Rezoning Transportation Analysis

Petition Number: 2017-079

Revision Log:	Date	Description
	05-18-2017	First Review

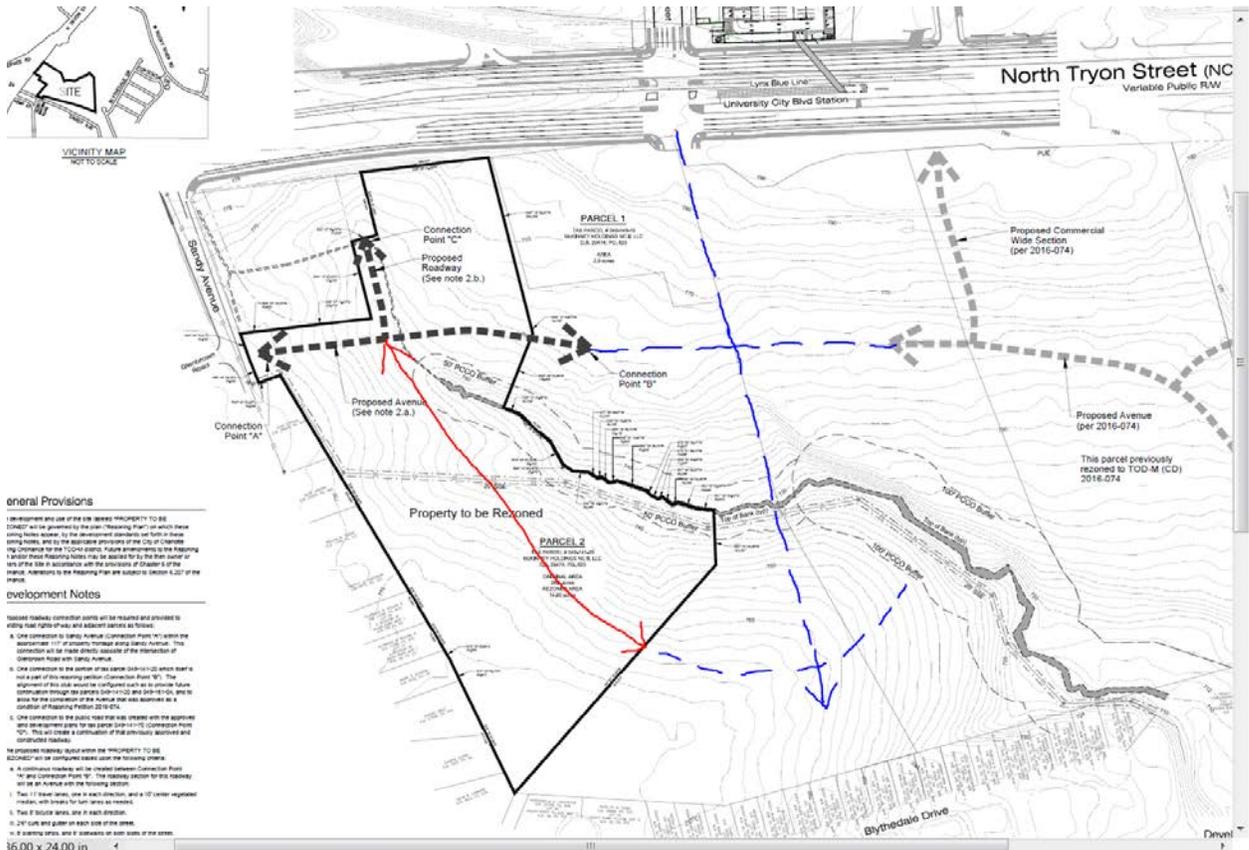
- Curbline:** The proposed zoning district has a setback measured from back of the proposed future curbline. The location of the future back of curb will be determined during the permitting process, since all the site's required network streets are proposed.
- Traffic Study:** A Traffic Impact Study/Transportation Technical Memorandum may be needed for the complete review of this petition, since land use and density are currently not provided on the site plan.

CDOT is waiting for additional land use and density information from the Petitioner so CDOT can estimate proposed daily trips. The number of proposed trips may also trigger the threshold for an NCDOT Traffic Study requirement. The petitioner should contact Ms. Wendy Taylor with NCDOT directly at 980-523-0000 to verify.

3. The petitioner should revise the site plan and add a conditional note(s) to specify the site's proposed land use and density so that daily projected trip generation volumes can be provided to our City Council.

4. The petitioner should revise the site plan to provide a local residential wide network street (either public or private) within Parcel 2 (see CLDSM U-03 plan view). This proposed street needs to connect to the proposed N/S Avenue Street between Connection Points "B" and "C" and sub along the site's southeastern rezoning boundary line (see below "red" network required street). This proposed local street network street will provide street connectivity to a future proposed local commercial east-west wide street in Parcel #04918104 connecting to North Tryon Street at Periwinkle Hill Ave. If the petitioner chooses to designate this proposed street as "private" a public access easement will be required. Also all private "network required" streets need to be designed and constructed to public street standards.

5. The petitioner needs to revise the site plan to add a conditional transportation note that states: The petitioner will work with CDOT before the public hearing to determine both the short and long-term intersection transportation needs (i.e. intersection geometry) at Sandy Ave. and Connection Point "A". CDOT is currently evaluating several intersection alternatives at this location. CDOT has scheduled a meeting with the petitioner's agent to discuss CDOT's proposed intersection recommendations on May 31st and June 2nd.
